BLUE ASH

2A-R-B.F.

Suite: 157
Building D

CONSTRUCTION SUMMARY Forestside Estates Inc.	
PURCHASER: ISHA KAPOOR	
TEL:

GROUND FL.

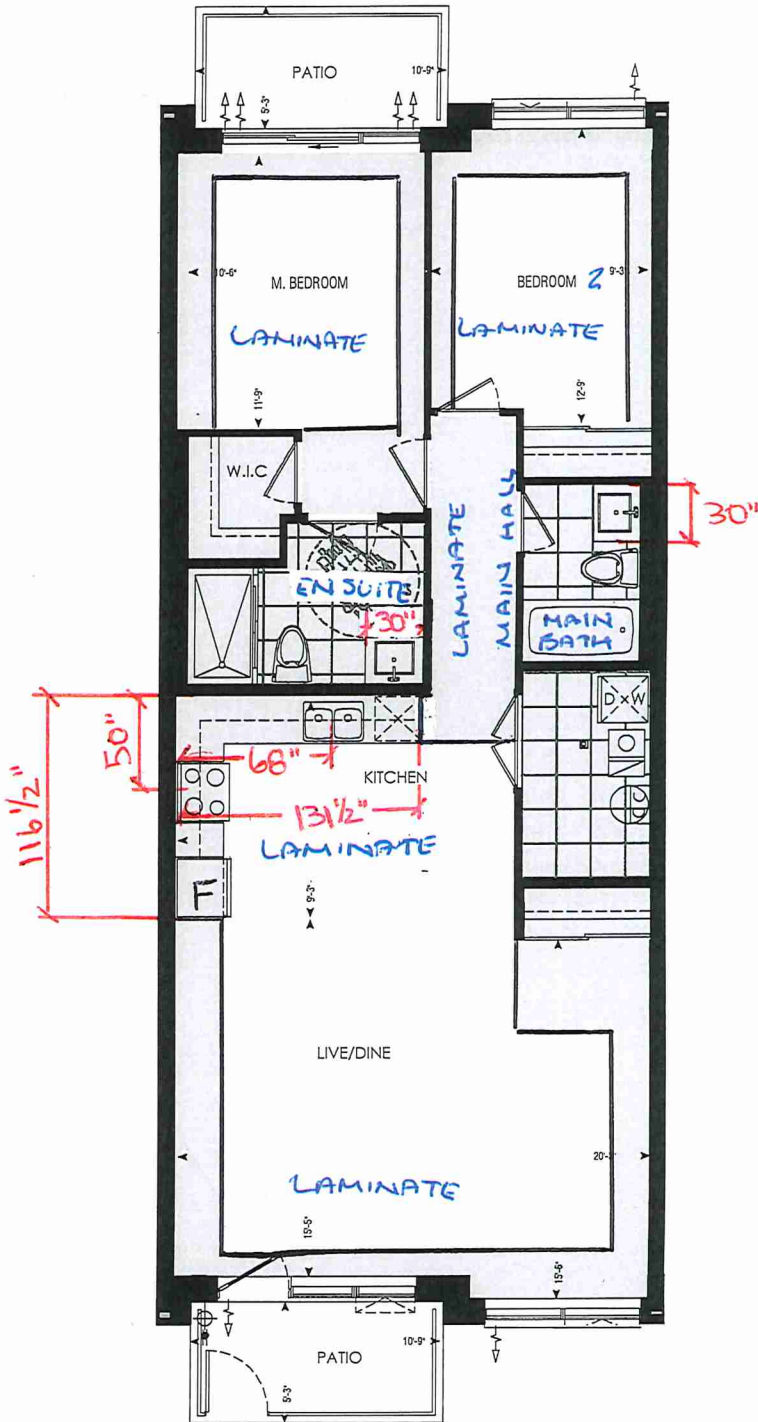
1 - KITCHEN-PLUMBING - Install the builders standard Top mount sink in the kitchen- Install the BLANCO HORIZON 2.0 (7") Top mount Sink- Model # 401124 (see sketch) Note:
1 - MASTER ENSUITE / MAIN BATH- Install the Standard 3" Splash throughout all bathroom vanity counter tops, where applicable. To include the Main Bath and the Master Ensuite Note:
1 - MASTER ENSUITE / MAIN BATH- Install the builders standard Plumbing Fixtures throughout all bathrooms, where applicable. To Include the Master Ensuite & Main Bath Note:
1 - KITCHEN/MAIN BATH/ MASTER ENSUITE - COUNTER-Stone slabs vary in size & all seams are visible & the fabricator reserves the right to position the seams as necessary. Note:
1 - MASTER BEDROOM - FLOORING - Install UPGRADED LAMINATE throughout The master bedroom where applicable in lieu of the builder's standard broadloom. Install 8" HIGHLAND SUTTON OAK EE-H-289. To include shoe moulding (See sketch) Note:

1 - BEDROOM 2 - FLOORING - Install UPGRADED LAMINATE throughout bedroom 2 where applicable in lieu of the builder's standard broadloom. Install 8" HIGHLAND SUTTON OAK EE-H-289. To include shoe moulding (See sketch) Note:
1 - PURCHASER AWARE AND ACCEPTS THAT ANY CHANGES MADE TO UPGRADES AFTER SIGNING THIS PURCHASERS EXTRA FORM ARE SUBJECT TO A MINIMUM ADMINISTRATION FEE OF \$1000 PLUS A 10% HOLDBACK FEE. Note:
1 - PURCHASER HAS ATTENDED A STRUCTURAL AND COLOR APPOINTMENT AT THE DECOR CENTRE AND HAS DECLINED ANY ADDITIONAL UPGRADES. Note:
